Responses to reviewers:

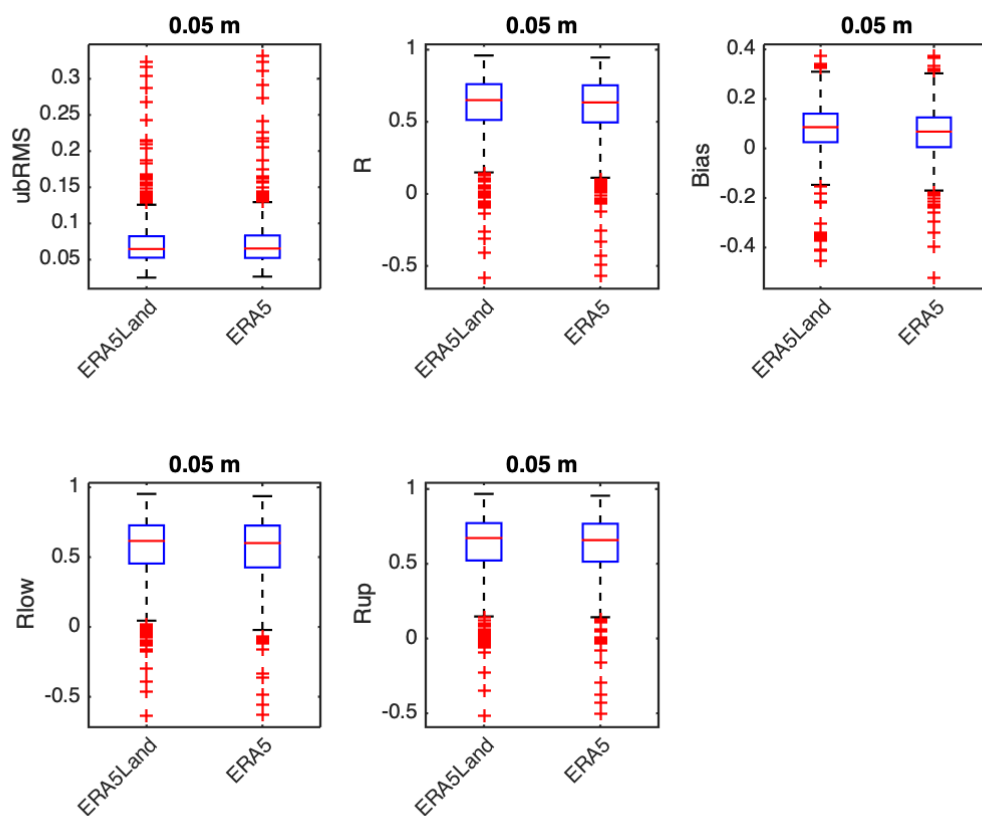
- **Line 391: From the boxplots one cannot tell that ERA5-Land on average performs slightly better than ERA5, as the results for the different regions are based on a different number of stations. Does this statement still hold if you perform the analysis for all stations in these regions together?**

We have produced the boxplots adding all the stations used of the ISMN, independently of the region. The plots are generated for the top soil layer, as for the root-zone we only had observations for North-America. As the reviewer can see, the boxplots are very similar to those shown in Fig. 7 (a-d), as most of the stations are located in North-America. The conclusions are the same, so we prefer to keep the current boxplots to show the break-down per regions, and which also show quite clearly that the impact of ERA5-Land is larger in the root-zone.

Following the reviewer comment, we have added in the results section a paragraph (Lines 418-424 of the revised manuscript) to stress the fact that stations have also been compared globally: "The results were also analyzed site per site taking into account the confidence interval of the Pearson correlation obtained for ERA5 and ERA5-Land versus the in situ measurements. A correlation difference is considered significant if the confidence intervals do not overlap. The Pearson correlation difference for ERA5 and ERA5Land at 5 cm is significant for 382 sensors, of which 64 % show higher correlation for ERA5 Land. The correlation difference at 20 cm is significant for 417 sites, of which 72% show a higher correlation for ERA5 Land. Finally, the correlation difference at 50 cm is significant for 479 sites, of which 88% show a higher correlation for ERA5 Land".
